Addendum No. 01

Subject: Stephen Decatur K-8 School
SDP Contract No. B-082 18/19

This Addendum, dated October 28th, 2020, shall modify and become part of the Contract Documents for the work of this project. Any items not mentioned herein, or affected by, shall be performed strictly in accordance with the original documents.

FA1.0

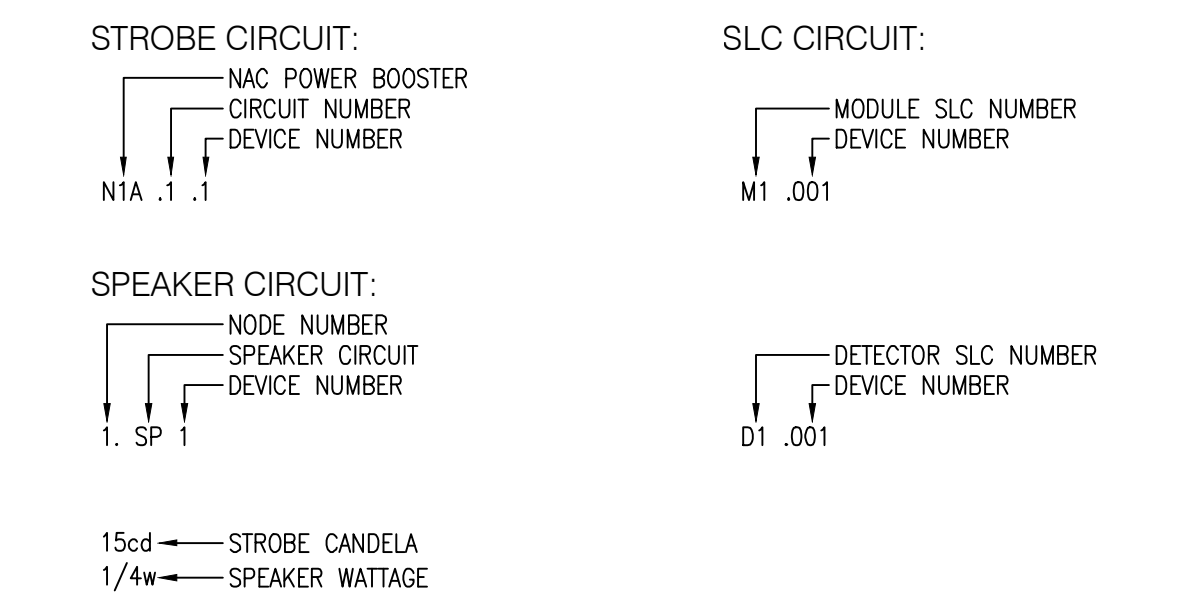
Fire alarm general note 24 on drawing FA1.0 is not applicable because there is no scope in the project to replace the fire protection or elevator systems. Please confirm this note can be removed.

It is correct that the fire protection/sprinkler systems and elevators are not being replaced, and any present are existing to remain; contractor scope of work shall include monitoring any existing points of monitoring for these systems, and as indicated in the latest contract documents.
